# Lakeview Subdivision

Columbia, Connecticut

Environmental Review Team  
Report

ENVIRONMENTAL REVIEW TEAM REPORT  
ON  
LAKE VIEW SUBDIVISION  
COLUMBIA, CONNECTICUT

# Drainage Areas

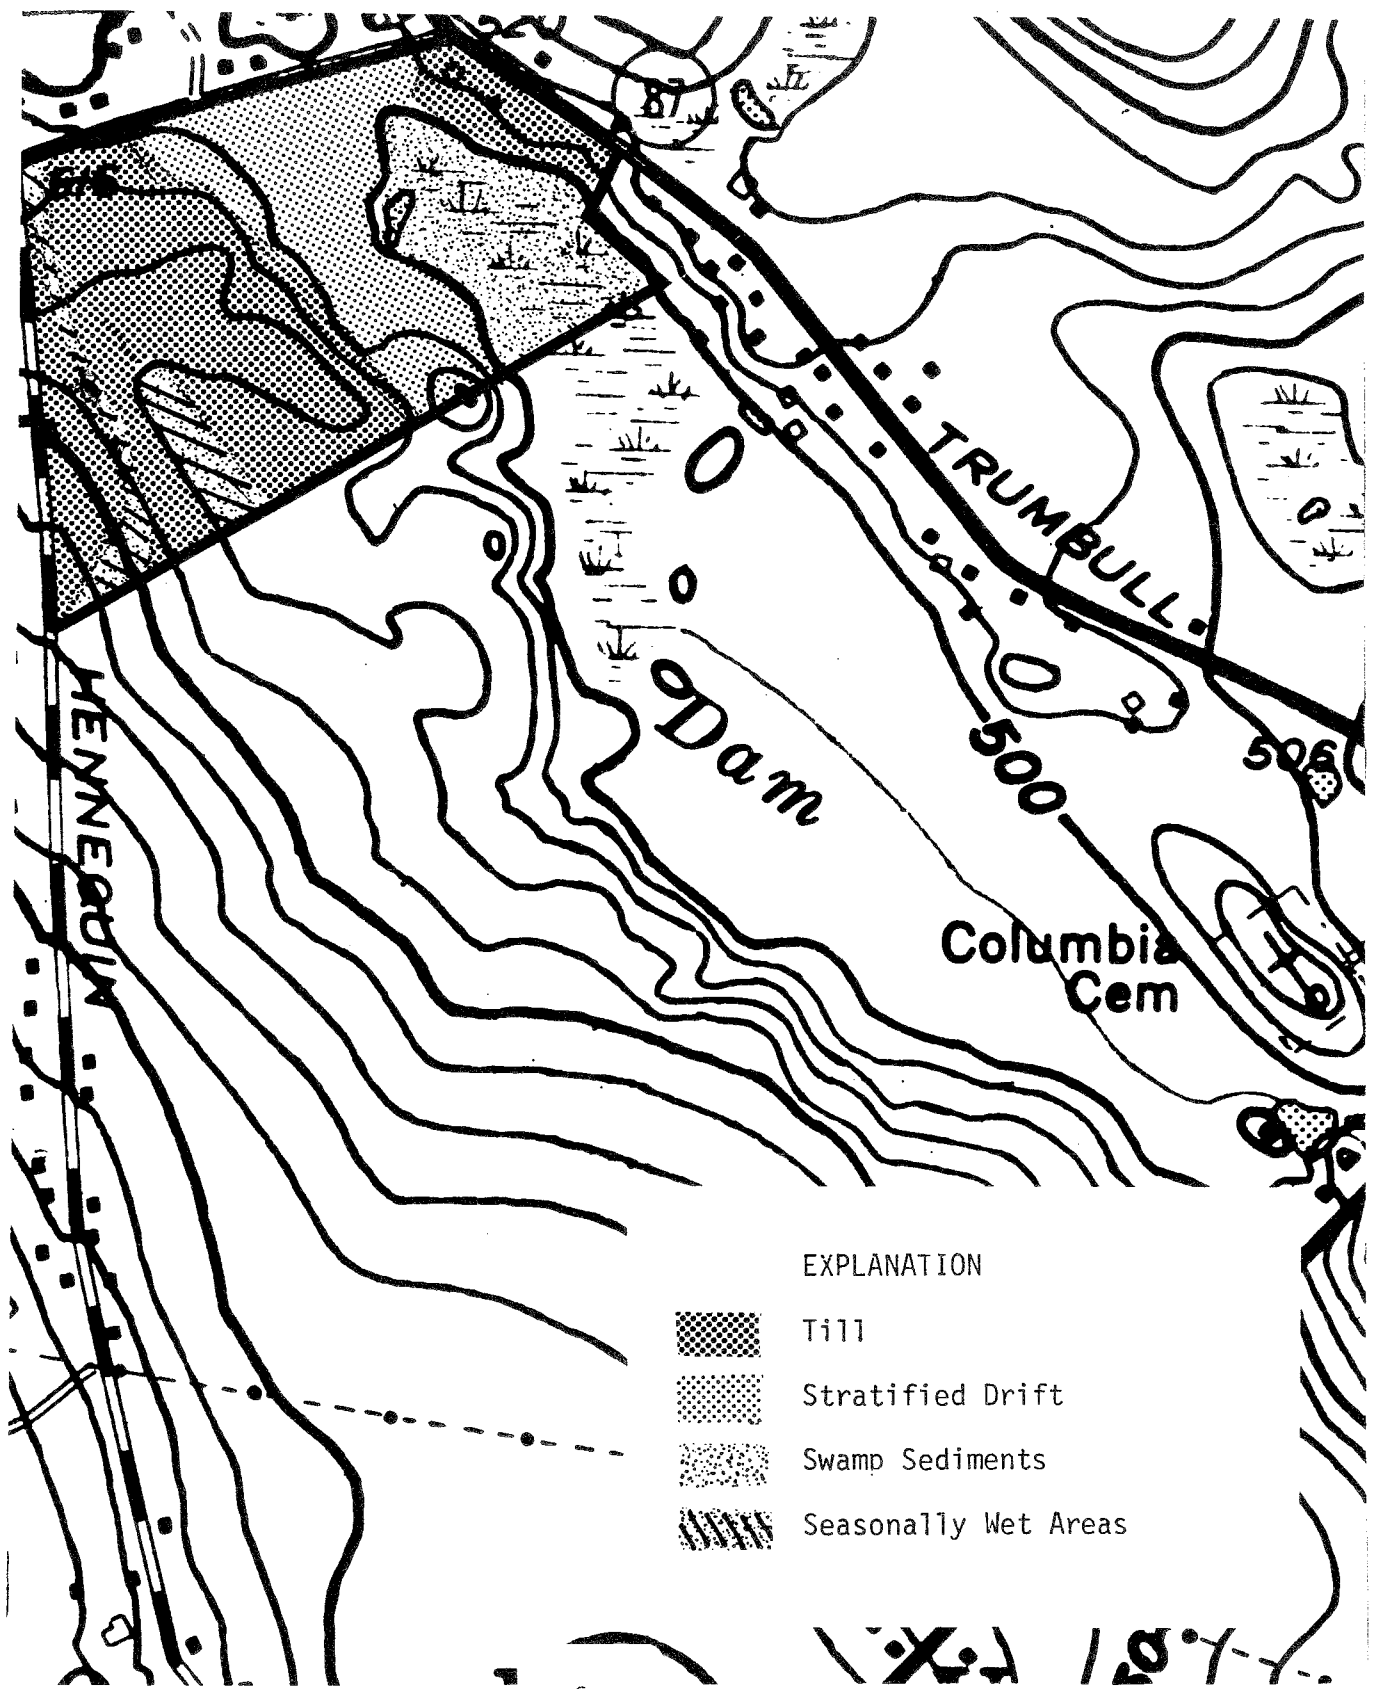
the property into three smaller drainage areas similar to the project engineer's approach (see Drainage Area map). Because most of the development (65%) will occur in subarea I, runoff changes are shown only for that drainage area. It is estimated that development in subarea I would increase the curve number only by 1 (from 65 to 66). Under these conditions, runoff depth for a 25-year storm event would increase from 1.99" to 2.08"; an increase of approximately 4.5 percent. Although it might be expected that runoff increases would be greater, due to the presence of the highly permeable soils, the curve number for approximately 8 acres of land (cultivated) in subarea I would actually be reduced to a lower curve number after development. Under existing conditions, the cultivated land in the northern part of the site has a higher curve number than would a developed one acre residential lot with 20% imperviousness. Once the lots have been developed on the cultivated lands, it is presumed grass lawns would be established. As a result, this type of vegetative cover would yield lower runoff than would the exposed cultivated fields.

Stormwater drainage emanating from catch basins in subarea II will be discharged south of the proposed cul-de-sac (Columbia Landing) into a well-defined channel. This channel empties into the wetland (Dam Brook) south of the spillway proposed for the detention area. Therefore, surface runoff from lots 1-5 and 16-19 would not be detained in the proposed detention area. Surface runoff from a small portion of lots 7 and 8 and a larger portion of lot 9 will continue to drain by sheetflow towards Lake Road. It will ultimately be intercepted by road drainage and discharged into Columbia Lake. Special attention should be focused on controlling the runoff discharged into the wetland to ensure scouring is minimized. Also, maintenance measures should be included in the runoff plan in case a significant buildup of sediments occurs at the discharge points in subareas I and II.

The applicant's engineer has prepared drainage calculations for the project which will help ensure that pipes are properly sized. The stormwater plan indicates that points of outflow will discharge into a rip-rap plunge pool. In order to prevent erosion beneath the splash pad, it is recommended that 18" of coarse gravel be placed beneath the plunge pool. This will help prevent the scouring of underlying material.

The area proposed for development represents about five percent of the watershed. In view of this and the proposed detention area, it seems likely that the increases in runoff generated by the proposed development would have a small impact upon peak flows into Dam Brook. However, a series of potential future developments in the watershed, i.e., southeast of Laurel Lane, east of Hennequin Road, each producing small peak flow increases, could ultimately result

in a substantial change in the flow characteristics of Dam Brook. As a result, these increases may lead to streambank erosion and possible downstream flooding, particularly at the culvert passing under Route 66. For this reason, it is recommended that any future developments in the watershed submit detailed hydrological information on pre- and post-development runoff volumes and peak flows from the respective properties. Consideration should be given to including stormwater control facilities, i.e. retention/detention ponds in future developments.

# Vegetation

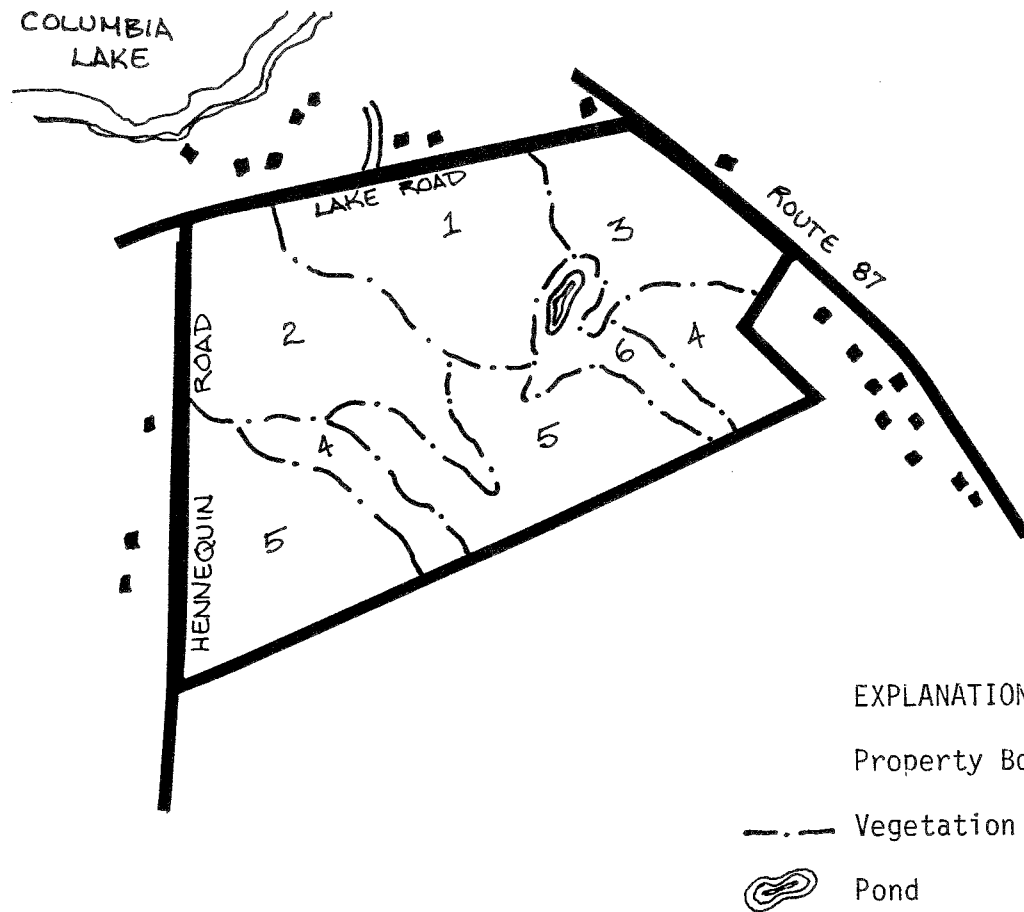
In Stand 2 at the intersection of Lake Road and Hennequin Road there are 6-10 large, old field white oak trees which were originally shade trees in the pasture. One of these oaks is particularly interesting and unique due to its extremely large size, spreading crown and symmetry. Any development and construction activity should be kept at least 25 feet away from the dripline of the tree crown. Trees are very sensitive to the condition of the soil within the entire area under their crowns. Development practices near the largest white oak, or any of the others that are to be retained, may disturb the balance between soil aeration, soil moisture level and soil composition. These disturbances may cause a decline in tree health and vigor, with a potential for tree mortality within three to five years. Care should be taken during the construction period not to disturb the trees that are to be retained both in Stand 2 and 5. In general, favor health, well-formed high vigor trees for protection over unhealthy trees as they are usually more resistant to environmental stresses brought about by construction.

Alterations in wetlands which permanently raise or lower the water table by restricting flow and natural stream drainage can have a negative effect on vegetation in these areas. Raising the water table may drown roots causing widespread mortality in the trees and herbaceous vegetation. Elimination of wetlands reduces wildlife breeding, cover and water sources also. The use of Stand 4 for a detention basin would decrease the value on the present quality of wildlife habitat.

The trees in Stand 5 have grown into a crowded condition over the years and although the stand is still healthy, if left to grow untended will become overcrowded and result in unhealthy trees. Trees in a crowded condition are susceptible to degradation from environmental stresses such as disease, insects, adverse weather and construction. An improvement thinning, prior to development, would remove undesirable trees and reduce competition for space, sunlight, nutrients and water. Over time this would allow trees to improve in health, vigor and stability. This type of thinning when properly implemented will improve aesthetic value of an area, improve tree health, improve wildlife food supply, and provide wood products. In Stand 5, timber and fuelwood could be removed and sold prior to development. The trees to remove in this type of "Intermediate Harvest" would be bent or crooked, leaning or have crown dieback. Trees to favor for retention should be tall and straight, usually the larger trees retained for future growth. A thinning would remove about 20 thousand board feet of sawtimber

and about 75 cords of tops and cull poletrees for fuelwood. Ideally, a thinning should occur prior to development to create an uniformity throughout the stand.

A public service forester or private forester should be contacted to help with the implementation of the suggested thinning.
